STAFF RECOMMENDATION 1206 Chapel Avenue January 20, 2016

Application: Demolition; New construction—infill; Setback determination

District: Eastwood Neighborhood Conservation Zoning Overlay

sheet title
 Elevations

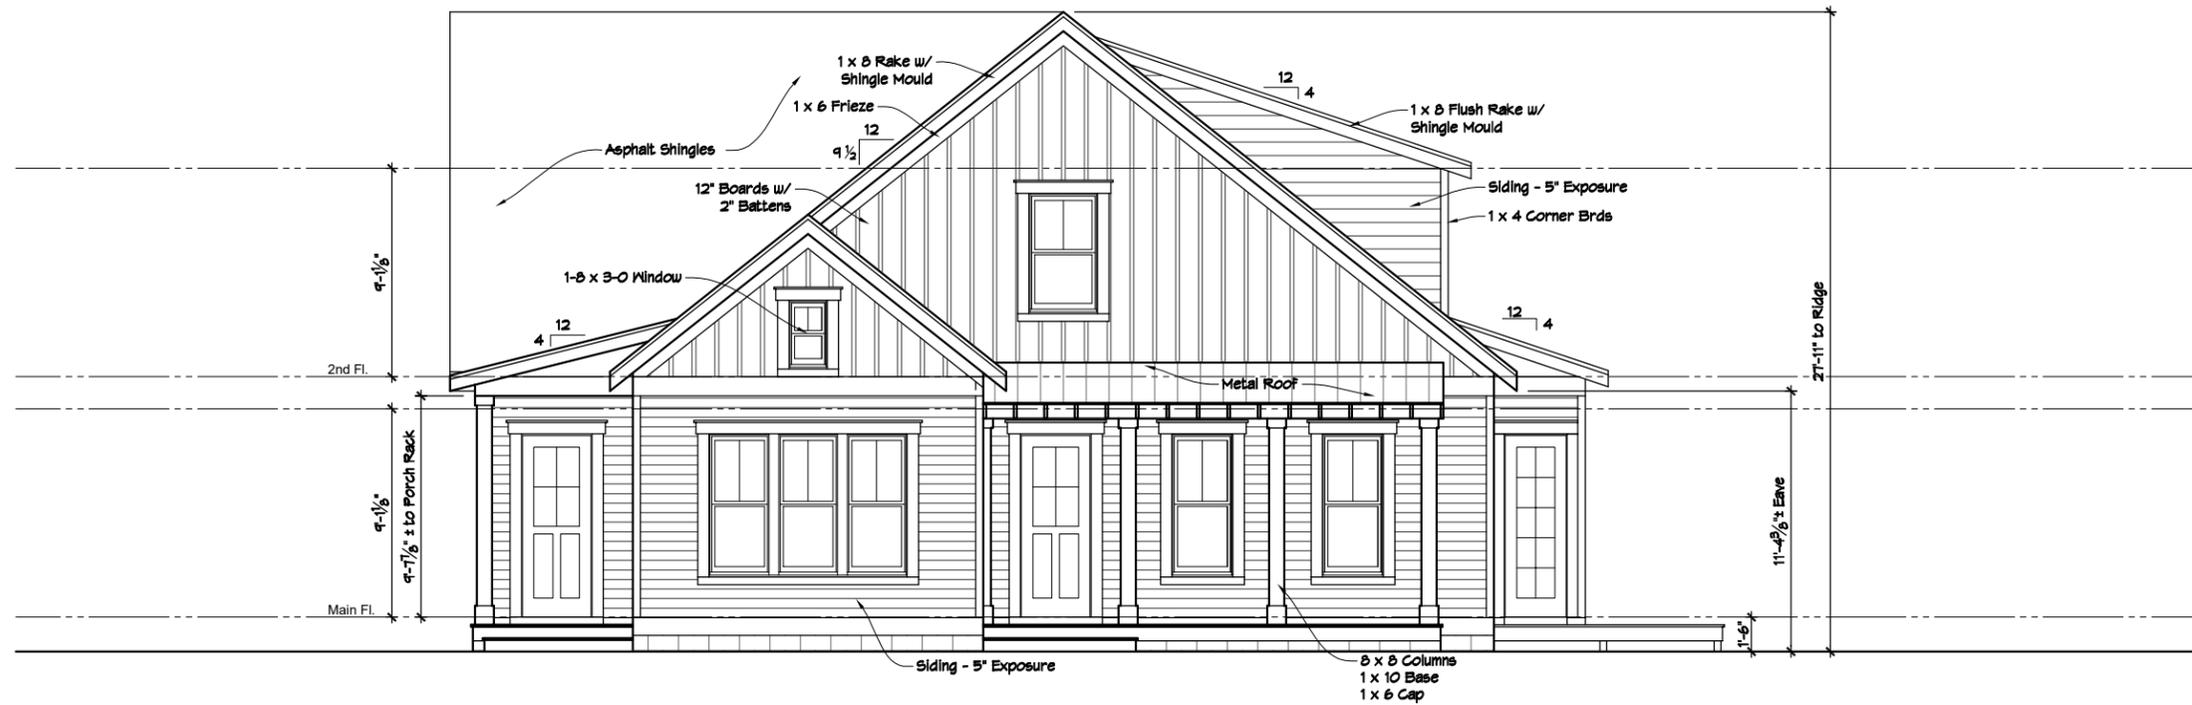
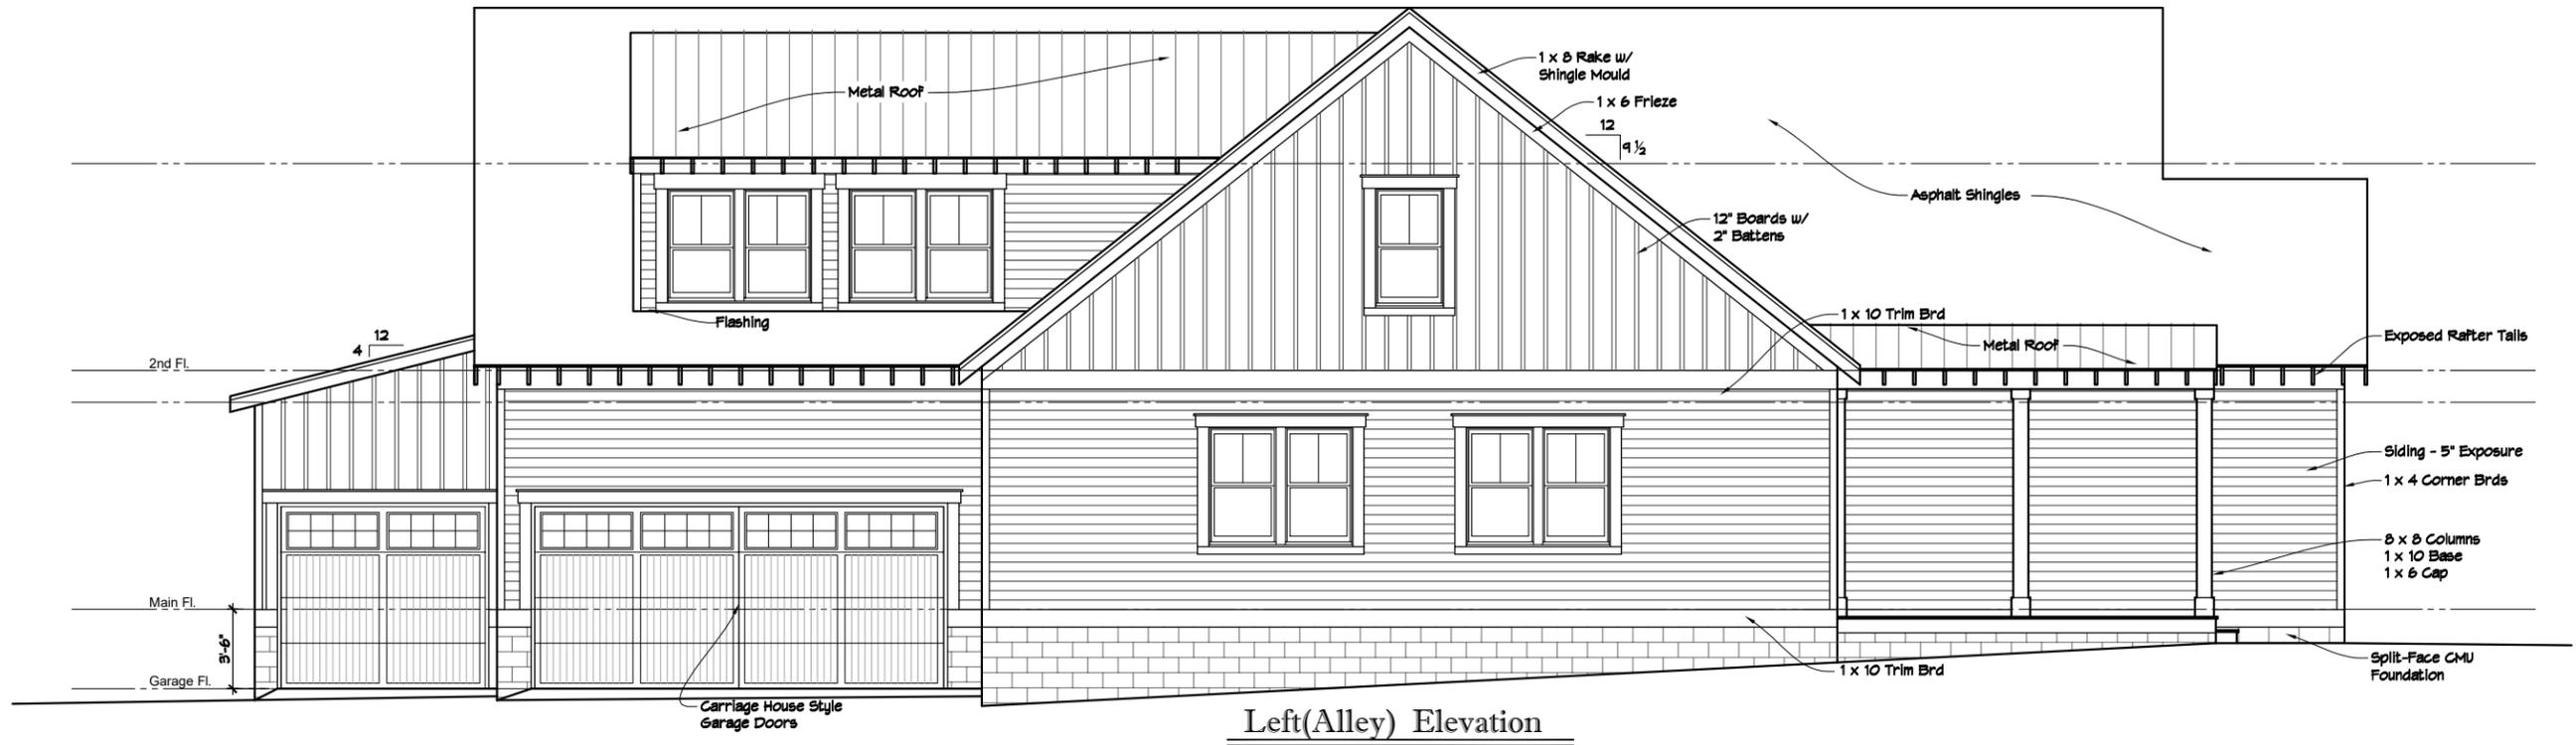
Height & Scale: The proposed duplex infill will be one-and-a-half stories in height, with an eave height of approximately twelve feet, ten inches (12'10") from grade and a ridge height of approximately twenty-eight feet (28') from grade at the front. Staff finds this to meet the historic context where historic houses range in height from twenty-one feet to thirty feet (21' – 30'). The foundation height will be approximately one foot (1') at the front, but will increase towards the back because of the slope of the site. Staff recommends inspection of the foundation height and finished floor height during construction to ensure that they are consistent with the surrounding houses.

The width of the house at the front will be approximately forty-four feet, four inches (44'4"), and at its widest, the house will be forty-eight feet, four inches (48'4") wide. This is wider than typical historic houses in the immediate vicinity, which have widths between thirty and forty feet (30' – 40'). However, staff finds that the proposed width is appropriate because the site is unusually wide at seventy-three (73'). Therefore, the rhythm of spacing along the street will not be greatly affected.

Roof form: The proposed roof will have a cross gable roof form with a slope of 9.5/12. The front porch roofs will be shed roofs with a 4/12 slope. The dormers will each be inset two feet (2') from the walls below, and will have shed roofs with a slope of 4/12. Staff finds that the proposed roof forms meet Section II.B.1.e. of the design guidelines.

Orientation: The duplex will have two separate entries on the front façade. The entry to the right unit will be behind a partial-width front porch that is six feet (6') deep. The entry to the left unit will be recessed behind a sixteen foot, eight inch (16'8") deep porch on the left portion of the side façade. Two front entries, with one being recessed behind a deeper portion of the porch on the side, is a configuration that is seen in historic East Nashville houses, and staff therefore finds the entries to be appropriate.

Proportion and Rhythm of Openings: The windows on the proposed infill are generally twice as tall as they are wide, thereby meeting the historic proportions of openings. There are no large expanses of wall space without a window or door opening. Staff finds the project's proportion and rhythm of openings to meet Section II.B.1.g. of the design guidelines.

sheet title
 Elevations

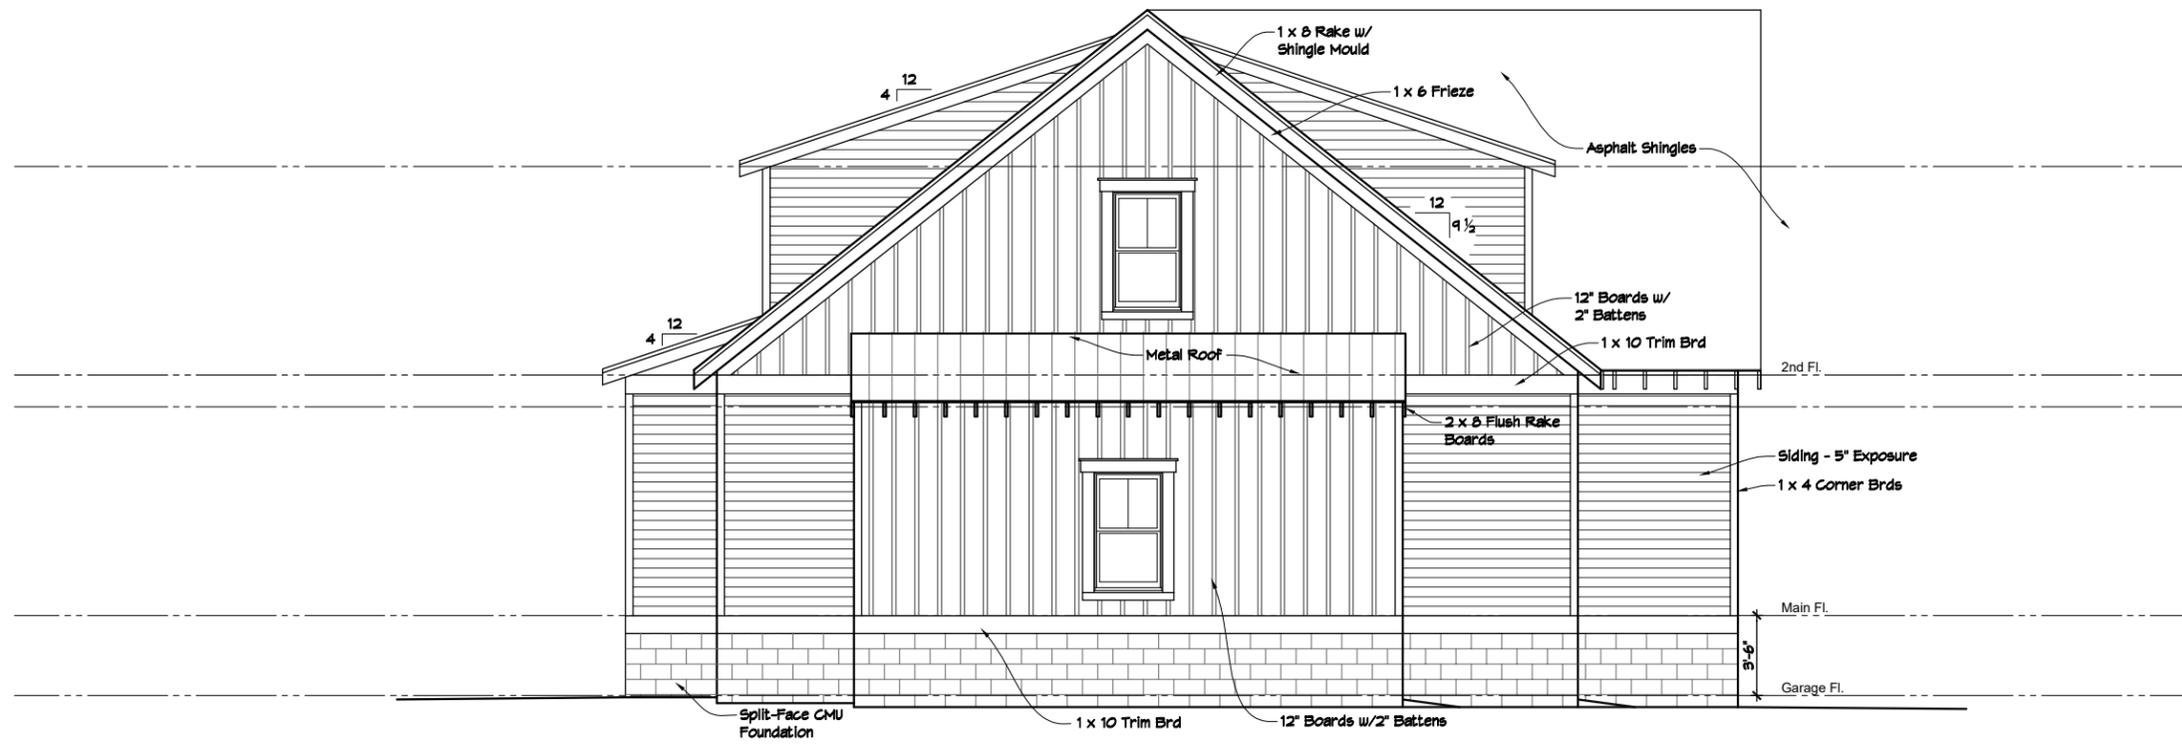
Outbuildings: The duplex will have three attached garage bays along its south side façade, facing the side alley. Although the design guidelines state that garages should generally be detached, and can only be attached when they are located at the basement level, staff finds these attached garages at the first floor level to be appropriate. The lot for 1206 Chapel Avenue is approximately forty feet (40') shallower than is typical for the neighborhood. Constructing a detached garage is impractical on this lot because of the truncated nature of the lot.

The attached garage bays will be accessed via the side alley that runs along the south side property line. They will be inset between seven and fourteen feet (7' – 14') behind the bulk of the house's side wall, which will help to reduce their visibility from Chapel Avenue. Staff finds that the proposed attached garages meet Section II.B.1.h. of the design guidelines.
